McDonald's Rebuild JSP13-01

Consideration of the request of Dorchen/Martin Associates, Inc., for Preliminary Site Plan and Stormwater Management Plan approval. The subject property is located in Section 36 at 21050 Haggerty Road, north of Eight Mile Road and east of Haggerty Road in the FS, Freeway Service District. The subject property is 1.25 acres and the applicant is proposing demolish and rebuild the existing McDonald's restaurant.

PLANNING REVIEW

Planning Review
McDonald's Rebuild
JSP13-01

Figure 1. Site of South Novi McDonald's Restaurant to be Rebuilt

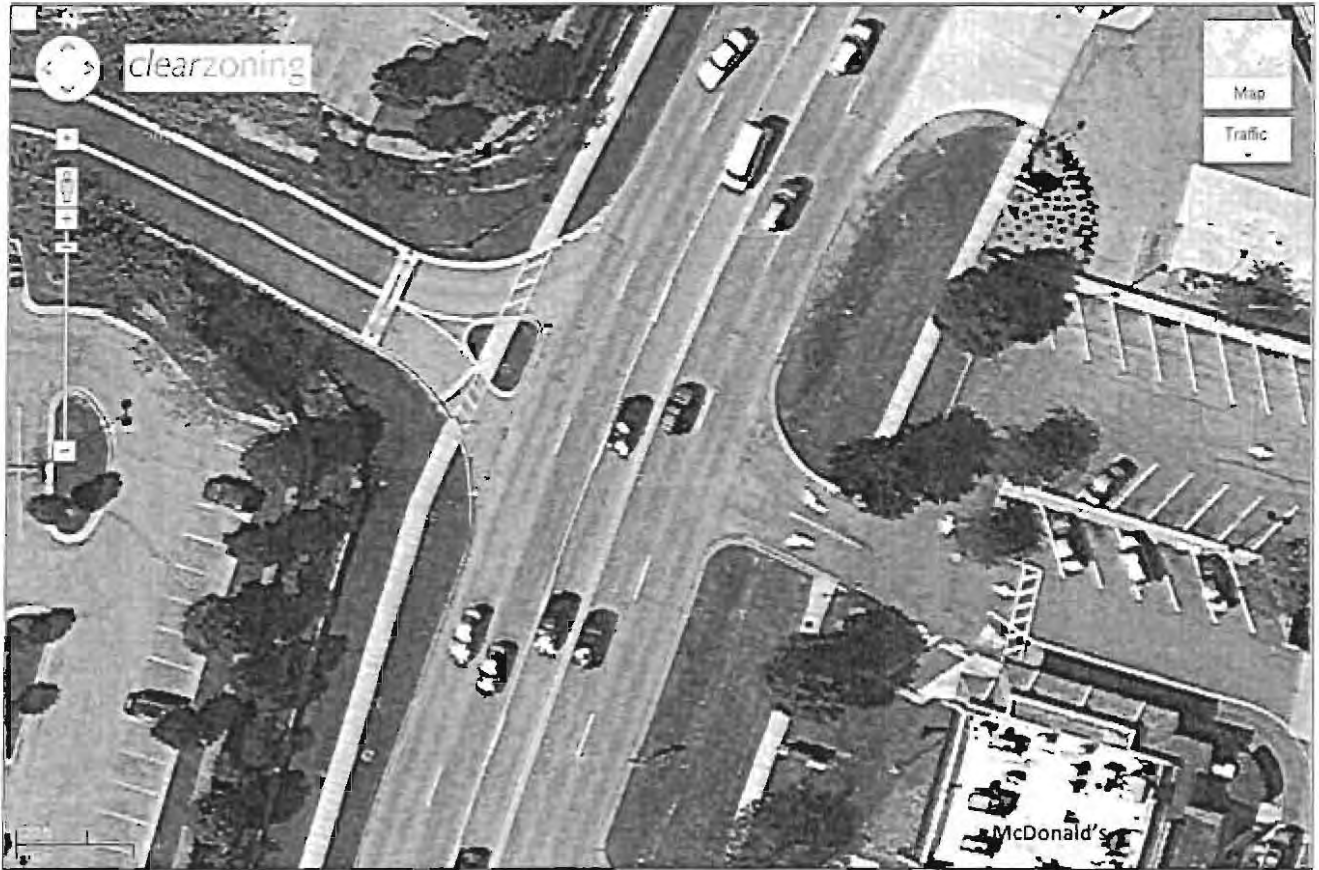
- a. We estimate that the proposed new site access drive would be only 63 ft from the gas station driveway to the north (near-back-of-curb to near-back-of-curb, versus 117 ft for the existing exit-only McDonald's drive). **The new access drive requires a Planning Commission waiver of the City's 230-ft minimum same-side driveway spacing for a 45-mph road (Design and Construction Standards, Sec 11-216(d)(1)d).** In considering the needed waiver, it should be noted that such a close spacing would be somewhat more disruptive to northbound through traffic than the existing deficient spacing, and drivers attempting to exit both drives simultaneously may have difficulty seeing safely by each other in seeking acceptable gaps in through traffic. However, a similar situation would exist relative to the Big Boy driveway to the south (Figure 1), if McDonald's were to locate their single new driveway at the south end of the site rather than the north end. (The northerly location would afford a 246-ft spacing relative to the Big Boy driveway, thus slightly exceeding the 230-ft minimum.)

- b. The striped centerline in the new access drive would be offset about 30 ft to the north of the physical centerline of the existing driveway on the west side of Haggerty. This may appear to require a Planning Commission waiver of the ordinary 150-ft minimum spacing for this direction of opposite-side driveway spacing (DCS Fig IX.12). However, since that standard is intended to primarily address potential "interlock" between left turns exiting the opposing drives – and since left turns from the west-side driveway are prohibited (by signing as well as the "pork chop" island) – **the Planning Commission may decide that the opposite-side driveway spacing standard does not apply in this situation.** In considering this matter, however, it should be noted (by comparing the site plan to our Figure 2 aerial photo) that it would be easier to cross over to the west-side driveway from the new McDonald's driveway than the existing McDonald's driveway. **To allay any traffic safety concerns with crossing over Haggerty at a somewhat awkward non-right angle, the Planning Commission may wish to have the applicant install a DO NOT ENTER (R5-1) sign on the north side of the west-side driveway, directly facing the new McDonald's driveway.**

3. Drive locations within 200 feet of site will be shown on site plan
 - a. We will request a waiver of the 230 foot minimum same-side driveway spacing for a 45-mph road
 - b. To be determined by Planning Commission
